KEYSTONE XL PIPELINE PROJECT

0499-SD-P4-419.7-421.1-S

Keystone XL Pipeline - Supplemental Information for Route Variation Report 0499

RV-0499-01 MLV-18 RELOCATION

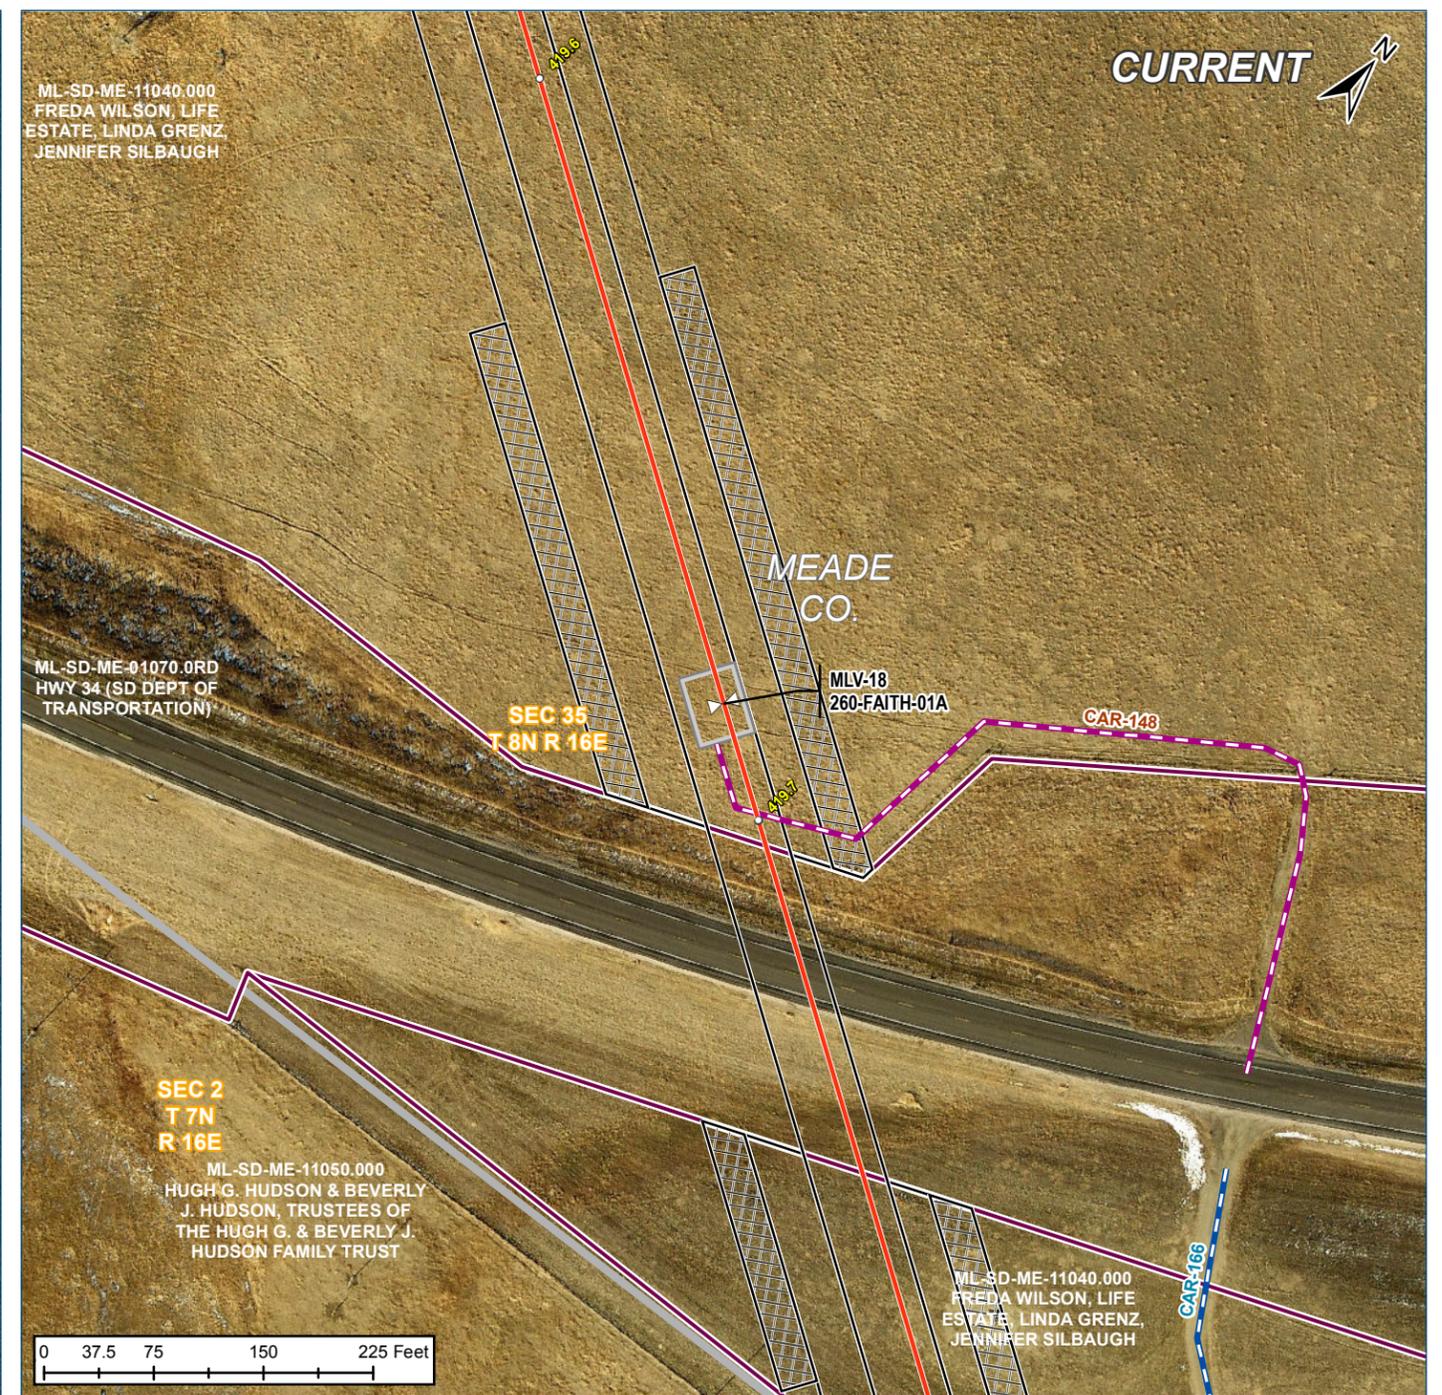
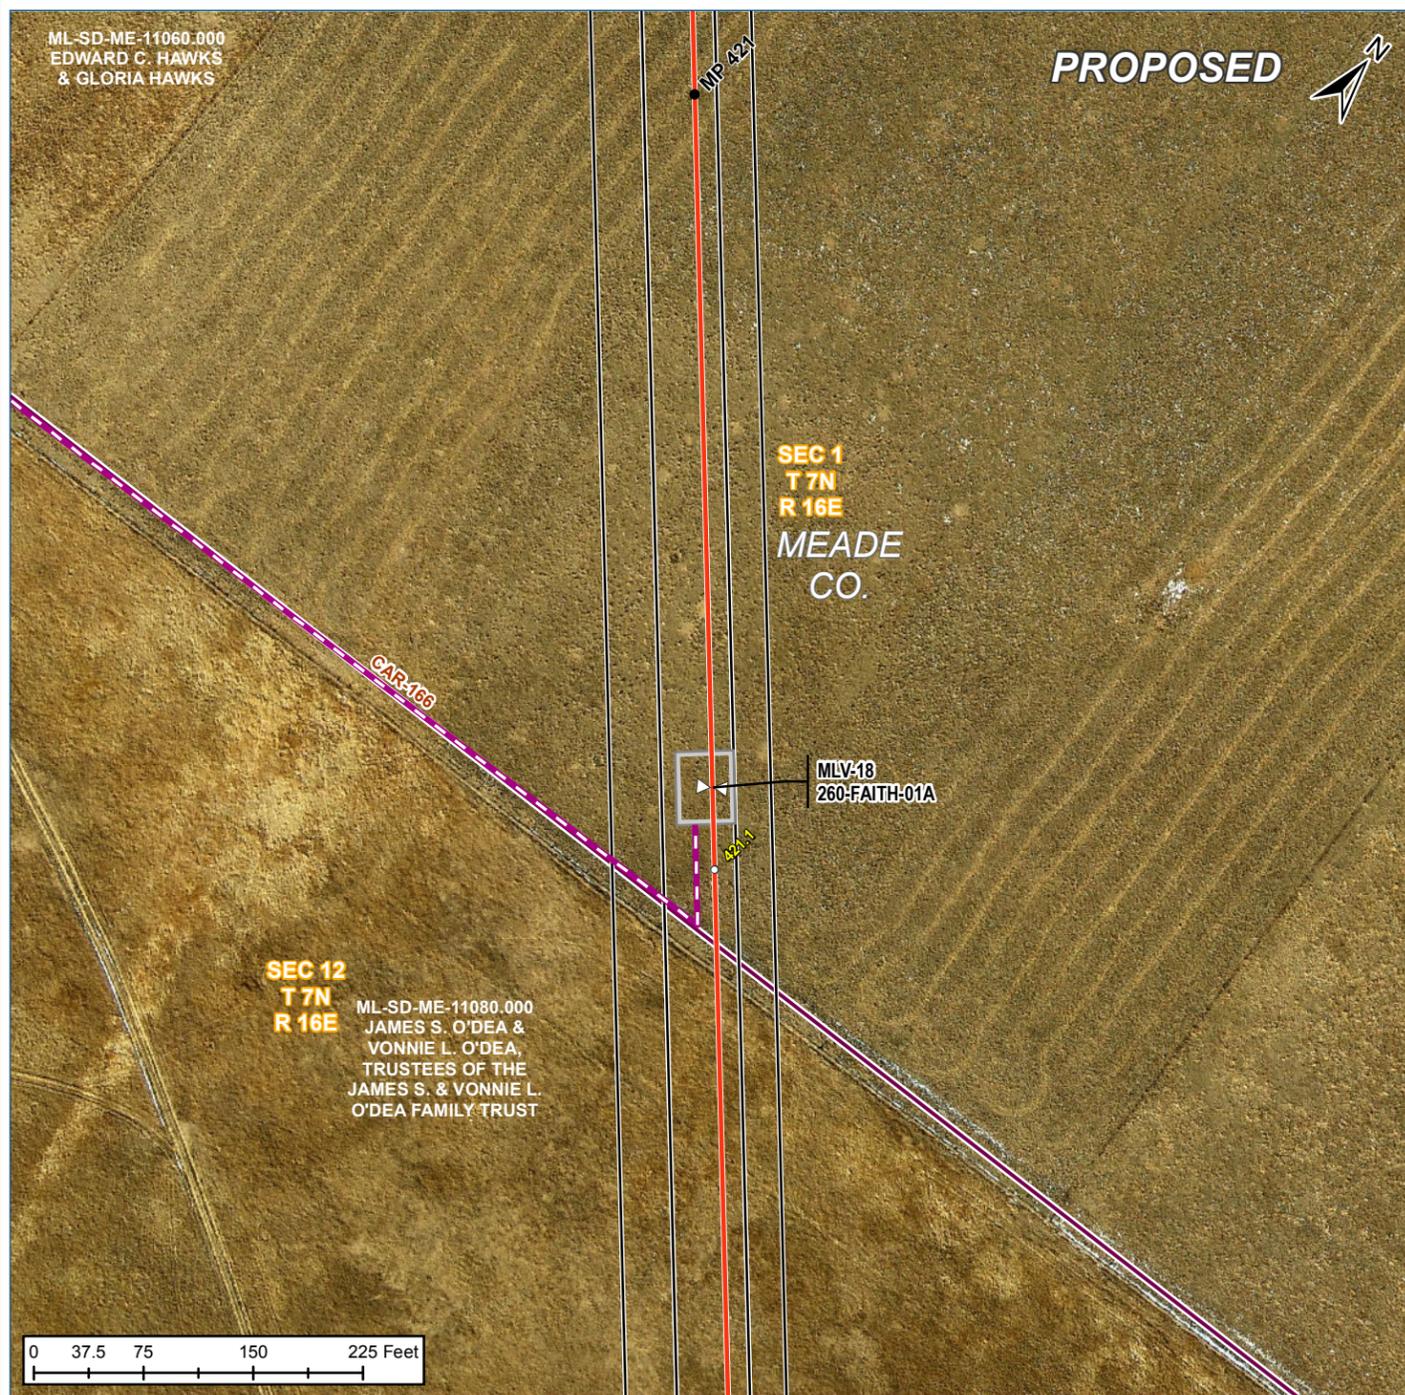
3	REASON FOR ROUTE VARIATION (Please include reason for route variation):		
	<p>The primary reason for this footprint change is to relocate mainline valve MLV-18 due to compliance requirement of being less than 10 miles away from the Cheyenne River (MP 429.8). Currently, MLV-18 is ~ 10.1 miles away from River, so the MLV-18 is being shifted 1.4 miles south.</p> <p>This proposed footprint changes are requested by Engineering and were field verified by civil survey.</p>		
	DETAIL ROUTE VARIATION (Please describe route variation in detail):		
	<p>Also see "Supplemental Info" for Valve Details.</p> <p>CAR-148 (Near MP 419.7, Temporary): Due to the relocation of MLV-18, CAR will now be temporary access road. Original Length: 684 ft. New Length: 624 ft. 1 Tract Impacted by modification: ML-SD-ME-11040 (Freda Wilson, LE; Linda Grenz, Jennifer Silbaugh).</p> <p>CAR-166 (Near MP 419.7, Permanent): Due to the relocation of MLV-18, CAR-166 will now be a permanent access road. It was also extended based on civil survey data to the new MLV-18 location. Original Length: 654 ft. New Length: 8,297 ft. 1 Tract Impacted by modification: ML-SD-ME-11040 (Freda Wilson, LE; Linda Grenz, Jennifer Silbaugh); ML-SD-ME-11050 (Hugh G. Hudson & Beverly J. Hudson, Trustees of the Hugh G. & Beverly J. Hudson Family Trust); ML-SD-ME-11060 (Edward C. Hawks & Gloria Hawks).</p>

KEYSTONE XL PROJECT
RV-0499-01 CAR-166 RELOCATION

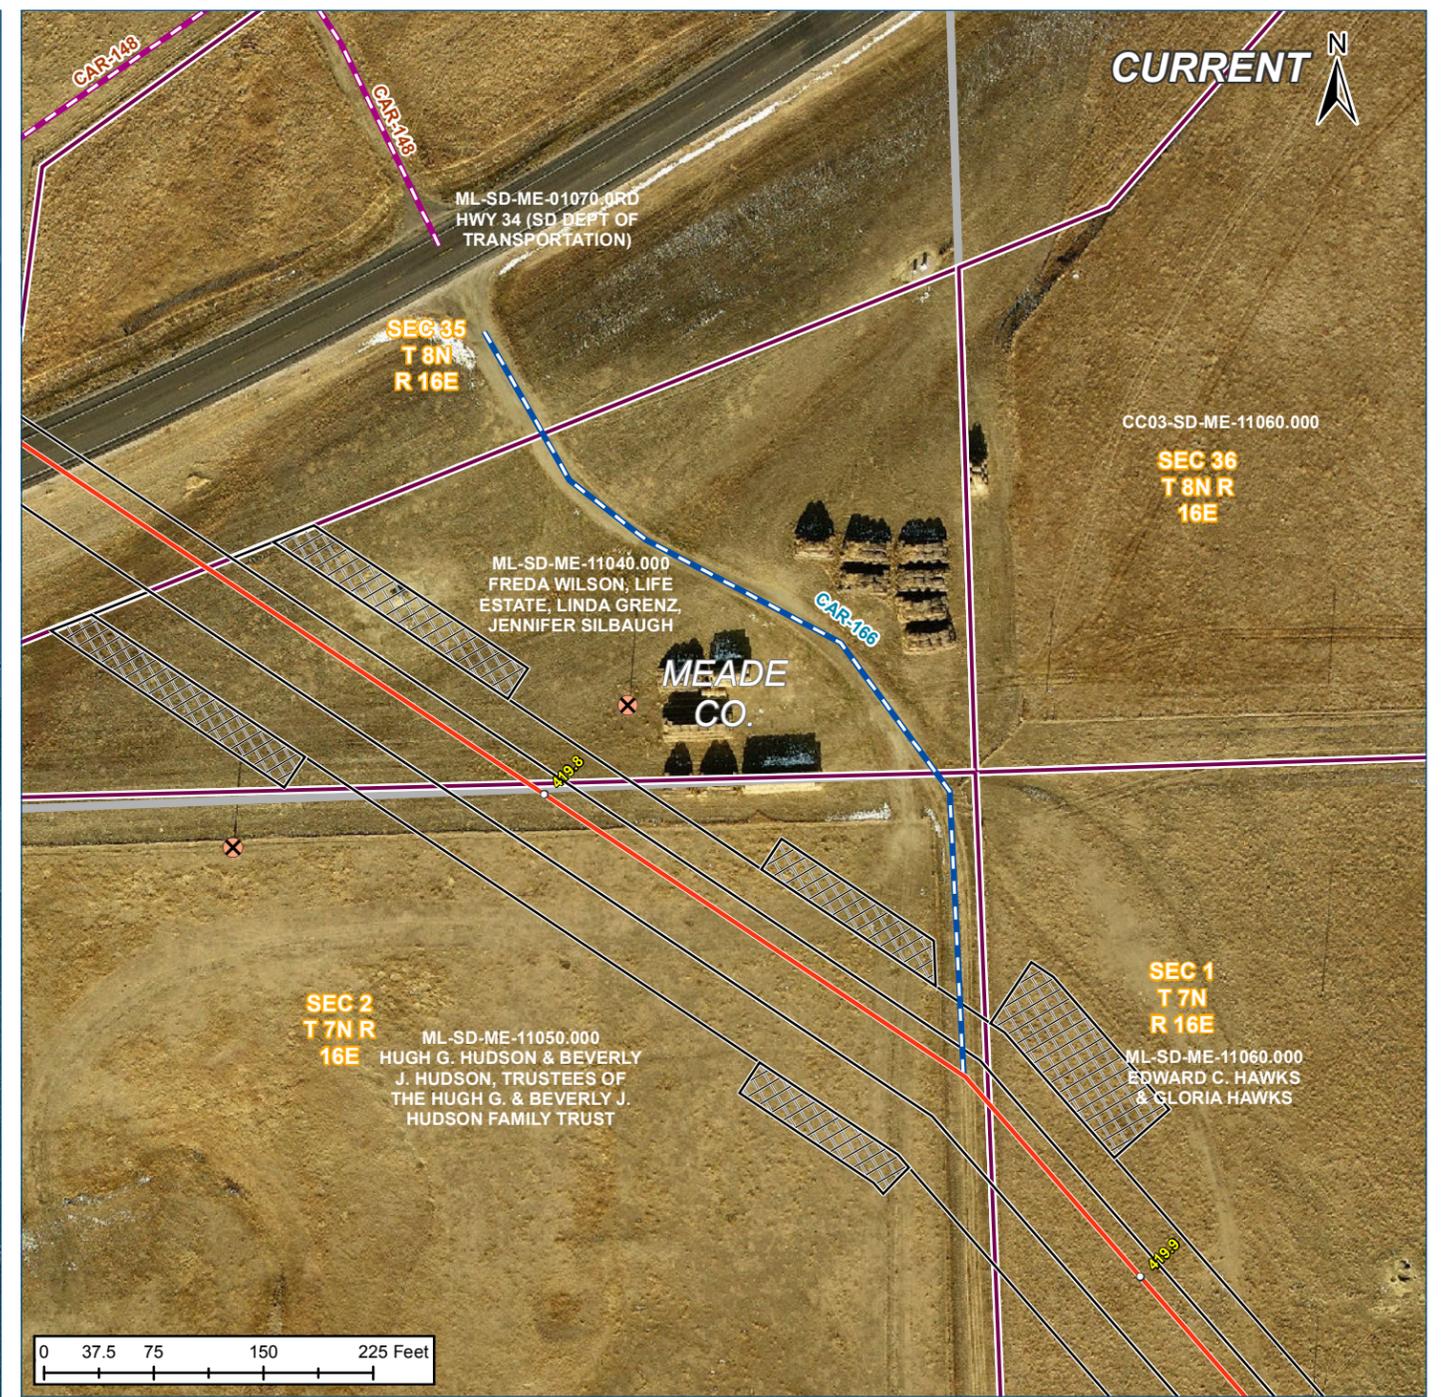
ADDITIONAL IMPACTS (Please include any additional impacts which may affect cost; crossings, induction bends, etc.):		
	<p>PHMSA Spacing requirements are not impacted by this check and manual valve relocation.</p> <p>A small portion of CAR-166 will require environmental survey.</p>		
	Is there an increase/decrease in the number of crossings? Yes <input type="text"/> No <input checked="" type="checkbox"/>		
	If yes, please list: <input type="text"/>		
	COST ANALYSIS (costs incurred or saved from the route variation)		
	Additional length of route realignment	<input type="text"/> ft.	\$ <input type="text" value="-"/> \$ 360/ft
	Additional length of side-hill construction:	<input type="text"/> ft.	\$ <input type="text" value="-"/> \$ 19/ft
	Additional length of wetland construction:	<input type="text"/> ft.	\$ <input type="text" value="-"/> \$ 195/ft
	Additional bore length (Road, RR):	<input type="text"/> ft.	\$ <input type="text" value="-"/> \$ 540/ft
